CHANGE/ERRATA INFORMATION

ISSUE NO: 3 1/95

Title: Helios Plus (2287A) System
Part Number: 865295
Print Date: February 1990
Rev.- Date: ---

Figure 3-5. Communications Parameter Selection Switches

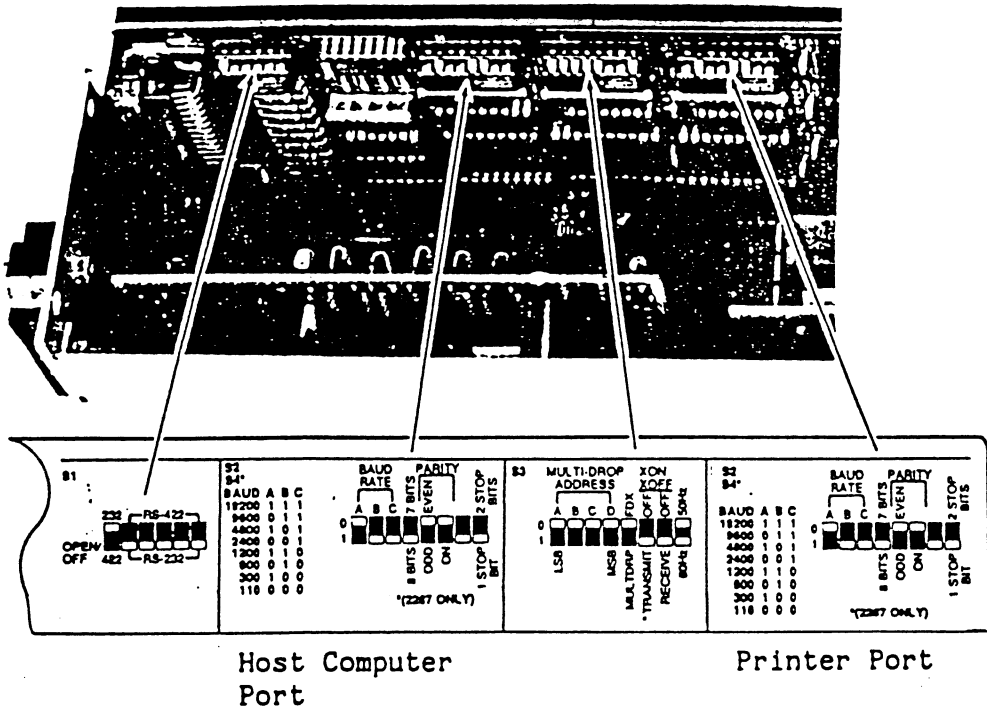
On page 3A-11, replace Figure 3-5 with:
